The Commission has issued the enclosed Amendment No. 60 to Facility Operating License No. DPR-59 for the James A. FitzPatrick Nuclear Power Plant. The amendment is in response to your application dated June 15, 1981.

The amendment revises Section 6.0 Administrative Controls of Appendix A and organization figures of Appendix B to reflect recent organization and management title changes.

JAMES A. FITZPATRICK NUCLEAR POWER PLANT

Amendment No. 60
License No. DPR-59

FIGURE 6.1-1

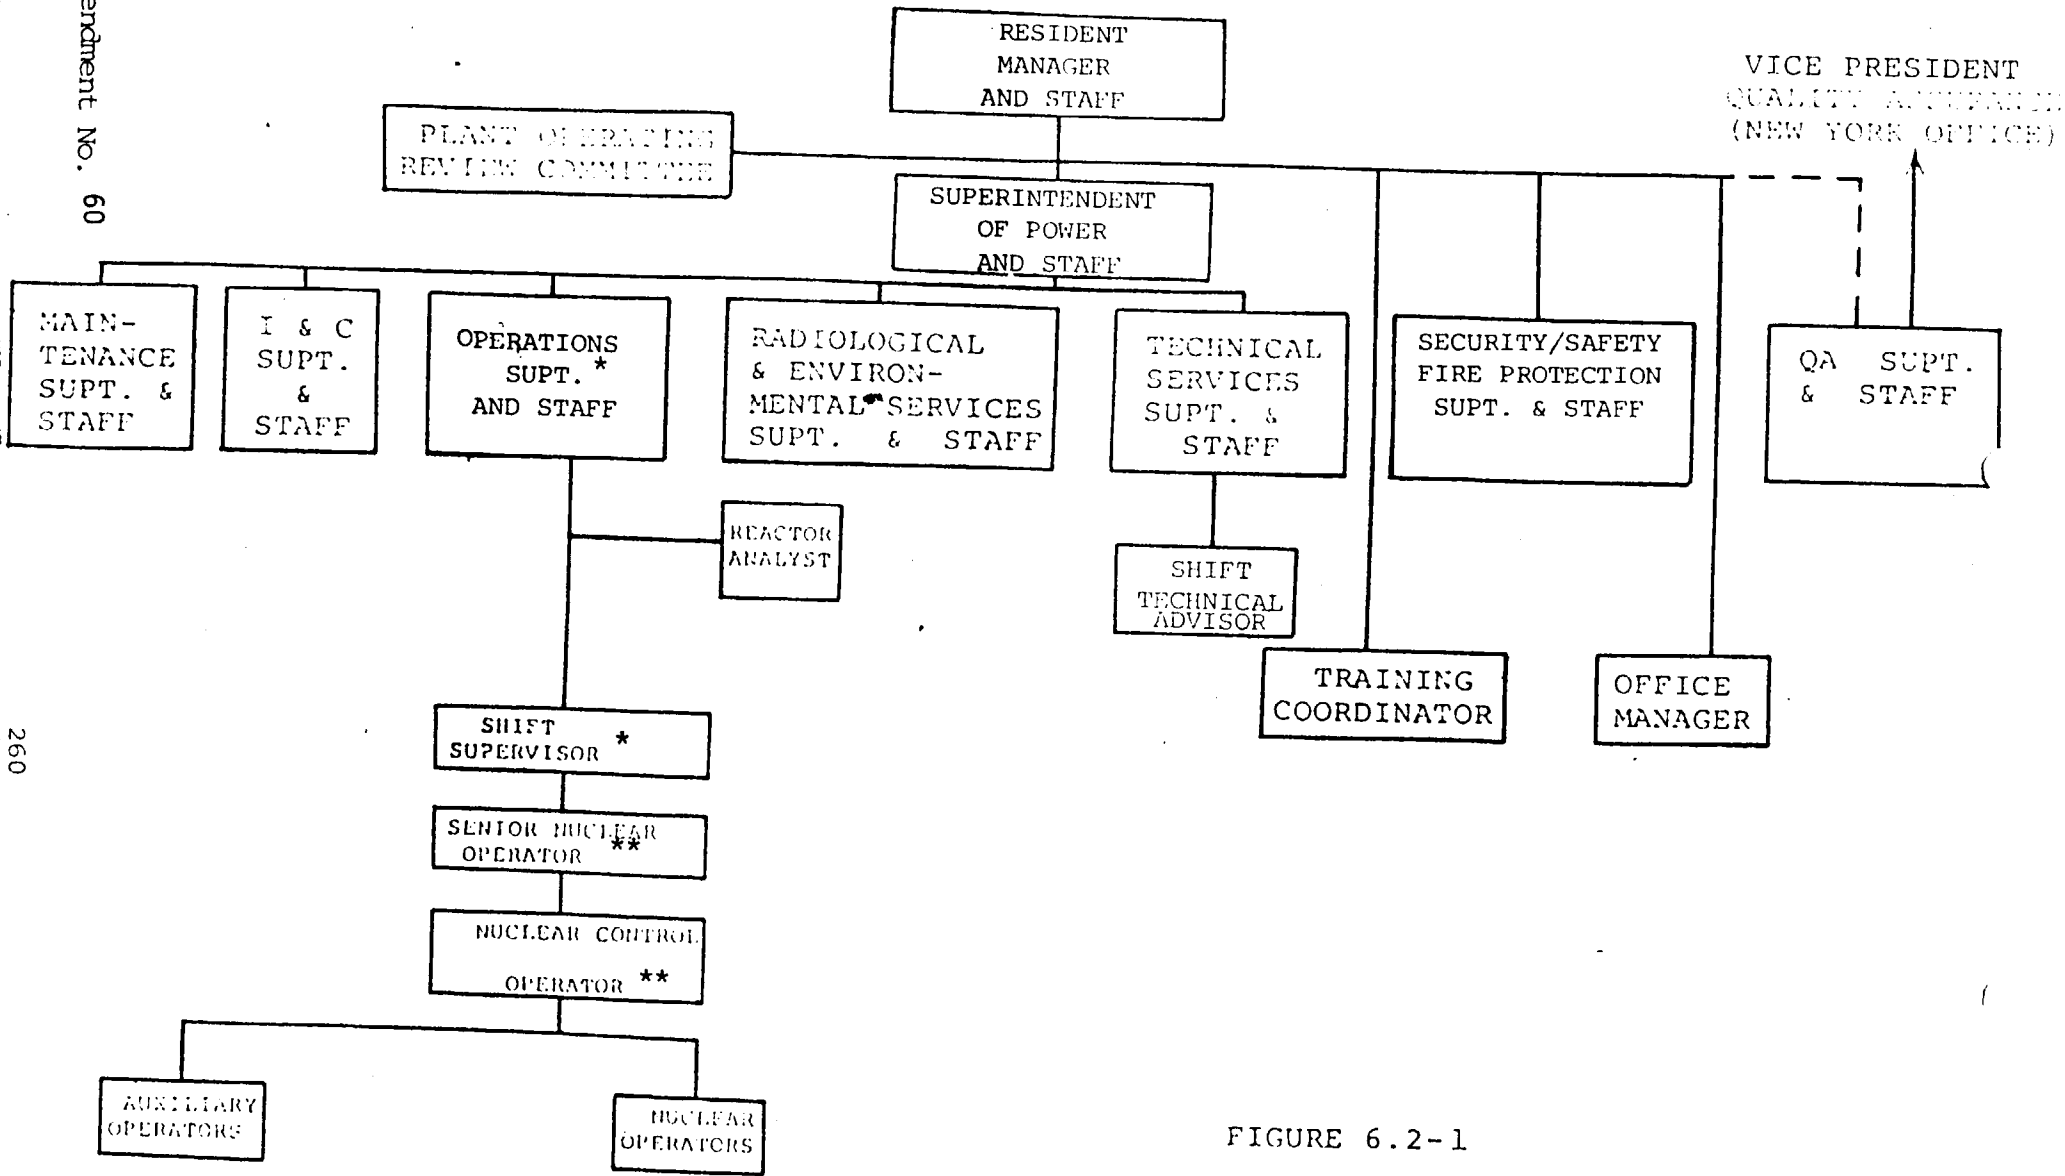
The Resident Manager is responsible for safe operation of the plant. During periods when the Resident Manager is unavailable, the Superintendent of Power will assume his responsibilities. In the event both are unavailable, the Resident Manager may delegate this responsibility to other qualified supervisory personnel. The Resident Manager reports directly to the Sr. Vice President-Nuclear Generation, as shown in Fig. 6.1-1.
